RESPONSE TO REQUEST FOR ADDITIONAL INFORMATION

APR1400 Design Certification

Docket No. 52-046

RAI No.: 407-8447

Schematic diagram of the raw water tank and FLEX equipment connection point

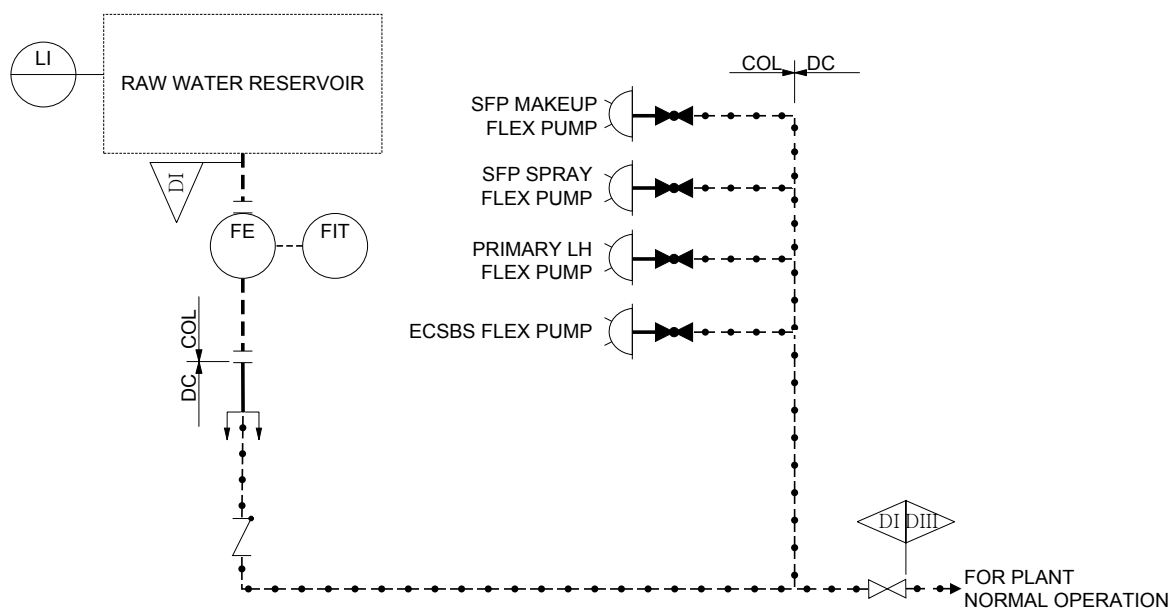
DCD Tier 2, Section 19.3.2.3.2 states that, in Phase 2 and Phase 3, makeup water will be taken from raw water tank (RWT) using a portable pump. It is not clear in the DCD whether there is a level instrument for the RWT being included in the design.

The applicant is requested to explain the design of RWT level instrument, or justify its elimination.

The design of the raw water system including the raw water tank is not involved in the DC phase. The level instrument will be provided to the raw water tank. To design the raw water tank

including level instrument, the site specific design data (water demand, site location, raw water source, etc.) will be determined during the construction phase. While the level instrument is provided for the raw water tank, specific design data is not determined (type, level setting, level alarm, etc.). A conceptual schematic diagram for the raw water tank is shown below as a guide for helping the NRC staff understand this response. Additionally, the information on the required makeup volume and water source in BDBEE is provided in Technical Report, APR1400-E-P-NR-14005-P, Table B-3.
